January 15, 2016

Re: United Heckathorn Superfund Site, Richmond, California

This technical memorandum presents a review of the Draft Focused Feasibility Study (Draft FFS) recently issued by the U.S. Environmental Protection Agency (USEPA) for cleanup measures at the Former United Heckathorn site in Richmond, California (Site; Figure 1). The Draft FFS presents the development and analysis of remedial alternatives for marine sediments that continue to be impacted by various contaminants of concern in the Lauritzen Channel (referred to herein as "the Channel"), following an initial cleanup attempt in 1996 and 1997.

Figure 3
Areas of Constrained Dredging in Lauritzen Channel
Engineering Review of Draft FFS
Former United Heckathorn Site, Richmond, California

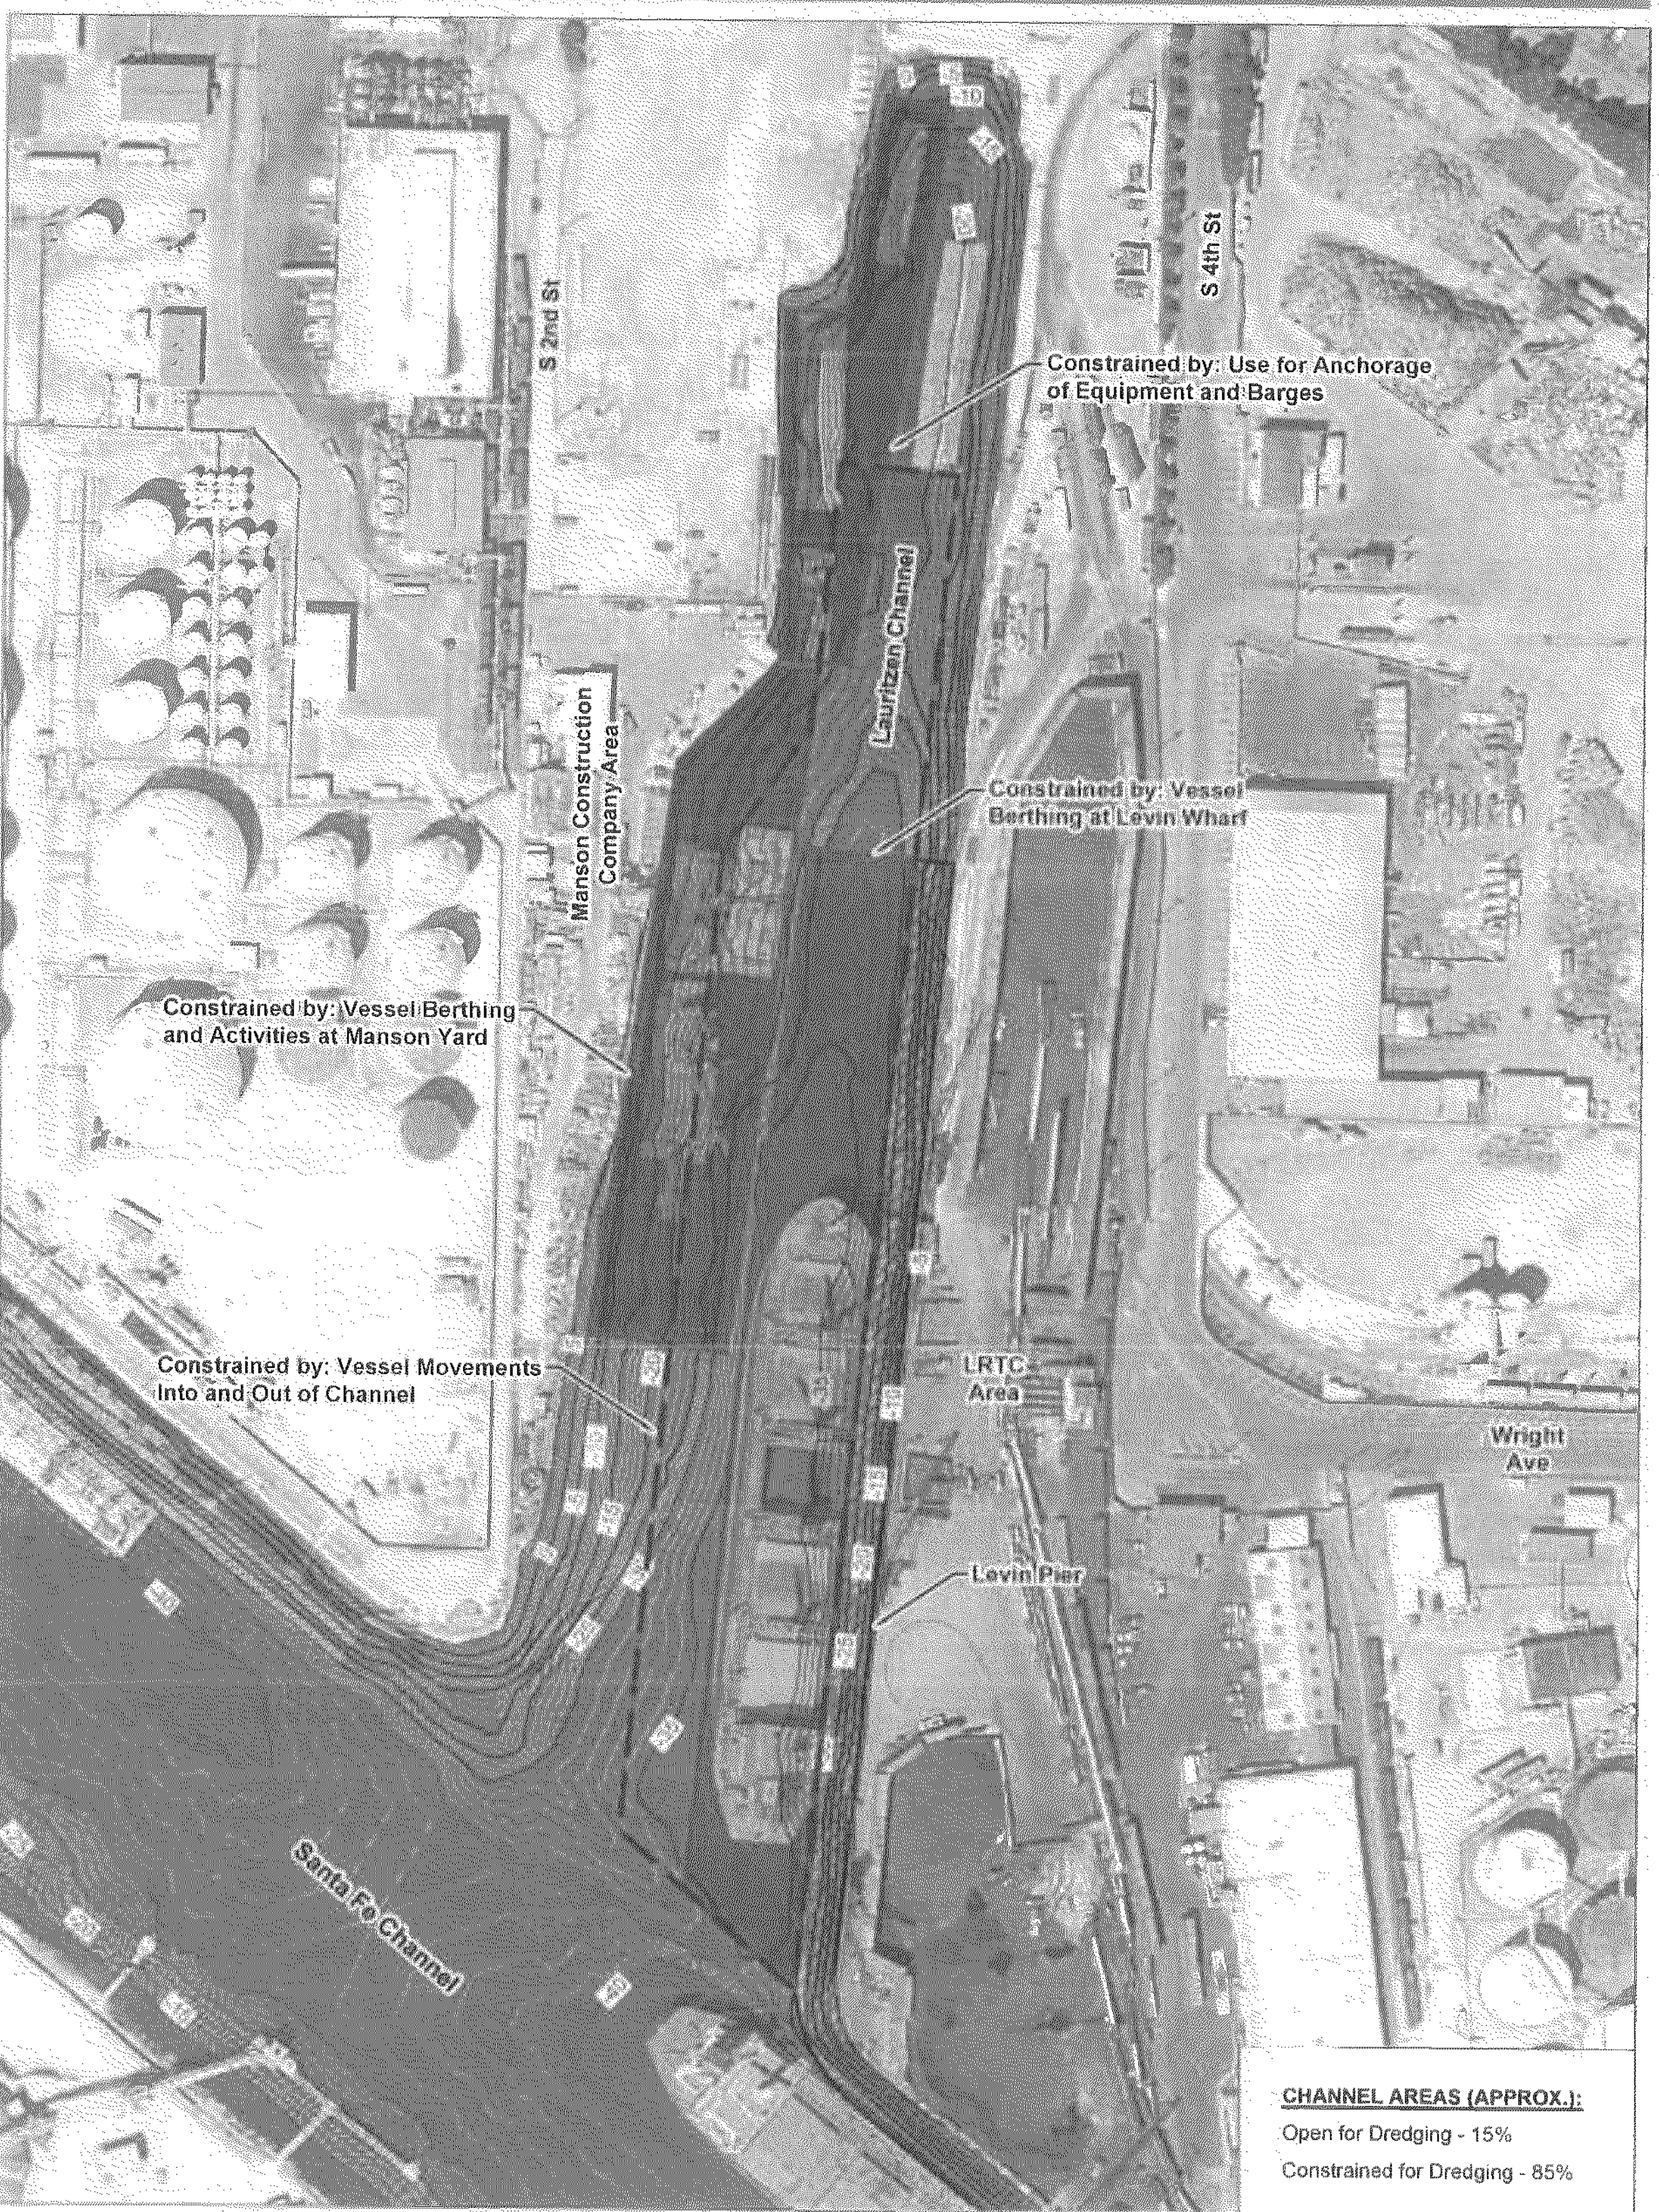
As is shown on Figure 3, constraints on the dredging process will result from a number of factors, including:

Figure 4
Conceptual Dredging Plan
Engineering Review of Draft FFS
Former United Heckathorn Site, Richmond, California

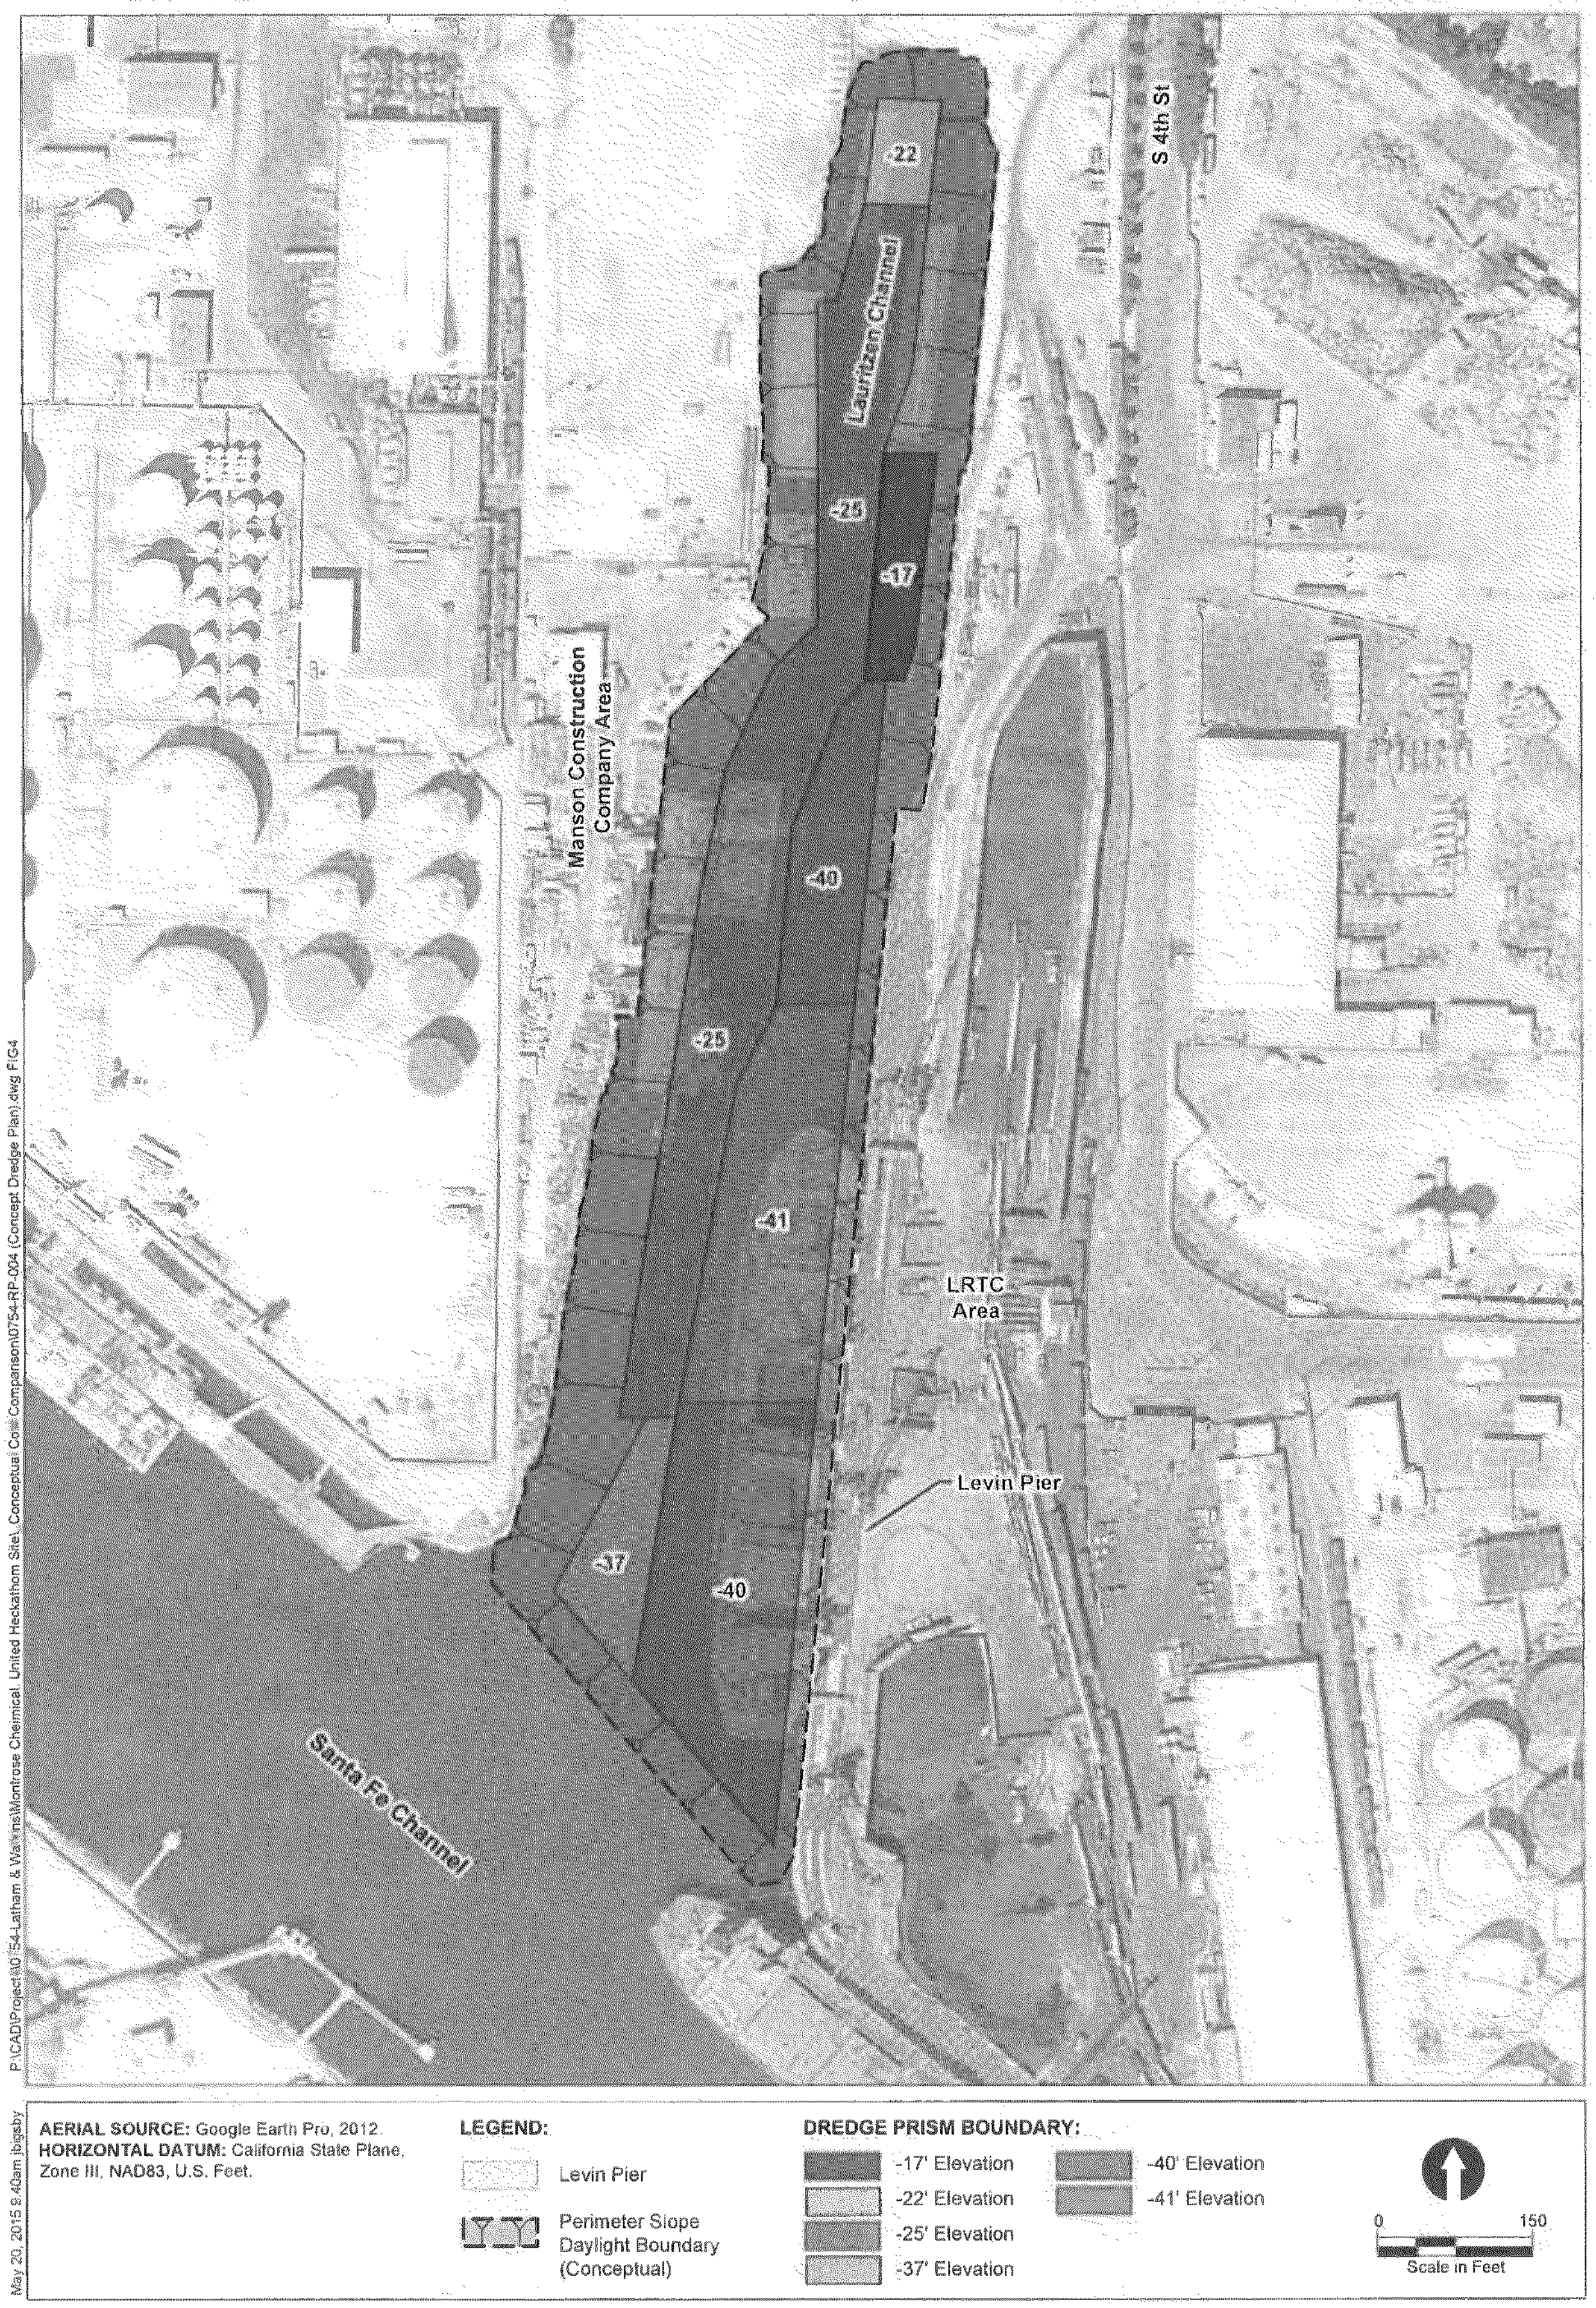
The conceptual dredge plan shown on Figure 4 was developed by identifying the required depth of sediment removal at each of the 2013 sediment cores (based on the presence of YBM and extent of cleanup criteria exceedances for dieldrin and DDT), and selecting a representative target depth for dredging in various areas of the channel. Due to localized irregularities in the sediment thickness and target depth, and the need to divide the project area into manageable subunits, it is necessary to establish target dredge depths that are frequently deeper than the YBM depths indicated at individual core locations. Dredging depths are frequently determined by taking the necessary depth of sediment removal, and rounding up to the nearest foot deeper.

The conceptual dredge plan shown on Figure 4 results in the following approximate dredging volumes for the full extent of the Lauritzen Channel:
